DESIGN KE	DRAWN BY RF	DART AEROSPACE LTD HAWKESBURY, ONTARIO, CANADA	
CHECKED KE	APPROVED H	DRAWING NO. DSI 9154	REV. A SHEET 1 OF 1
DATE 99.06.28		TITLE 350 BASKET	SCALE NTS
A	99.06.28	NEW ISSUE (TSR A1207)

DART SERVICE INSTRUCTION

TO AMEND INSTALLATION DRAWING D350-607 REV E

CANADIAN STC: SH94-14
US FAA STC: SR00213NY

D350-607-041 LH BASKET INSTALLATION

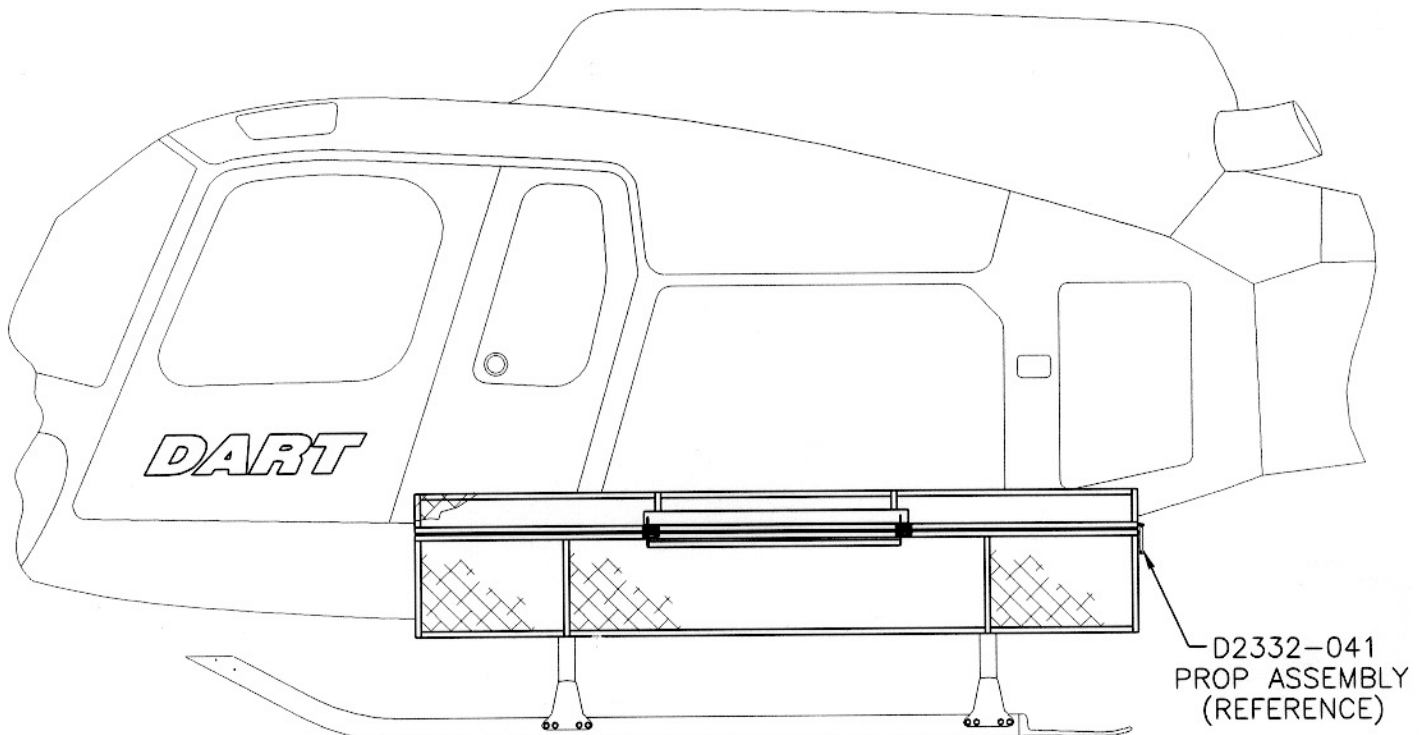
D2332-041 PROP ASSEMBLY OF D350-607-042 RH BASKET CAN OPTIONALLY BE MOVED TO AFT END OF BASKET TO MAKE D350-607-041 LH BASKET. USE EXISTING HARDWARE AND ENSURE NUTS FACE AFT.

NOTE: THE LOCATIONS OF THE FWD AND AFT MOUNTING BRACKETS MAY NEED TO BE SWITCHED TO AGREE WITH INSTALLATION DRAWING D350-607 REV. E.
